Rezoning Transportation Analysis

Petition Number: 2019-085

From: Robyn Byers, PhD
Robyn.Byers@charlottenc.gov
704-336-7404

Reviewer: Kevin Parker, EI
Kevin.Parker@charlottenc.gov
704-432-6511

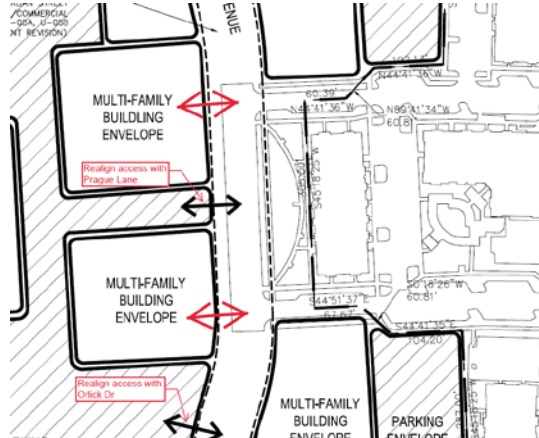
4. ~~**Steele Creek Area Plan**~~
 - a. ~~The petitioner should revise the site plan and conditional note(s) to commit to construct an 8-foot planting strip, and 6-foot sidewalk on Arrowood Rd, per the Steele Creek Area Plan. CDOT requests for the back of 6-foot sidewalk to be placed 53 feet from centerline, to plan for a future 12-foot multi-use path. The site plan should label and dimension both items from the back-of-curb and gutter/road centerline.~~
 - b. ~~**Comment Revised/Outstanding** The petitioner should revise the site plan and conditional note(s) to construct the future Arrowood Road/Whitehall Park Drive Connection to the intersection of the Savoy Corporate Drive's future extension alignment, per the Avenue — Two Lane Undivided cross section provided within the Steele Creek Area Plan.~~
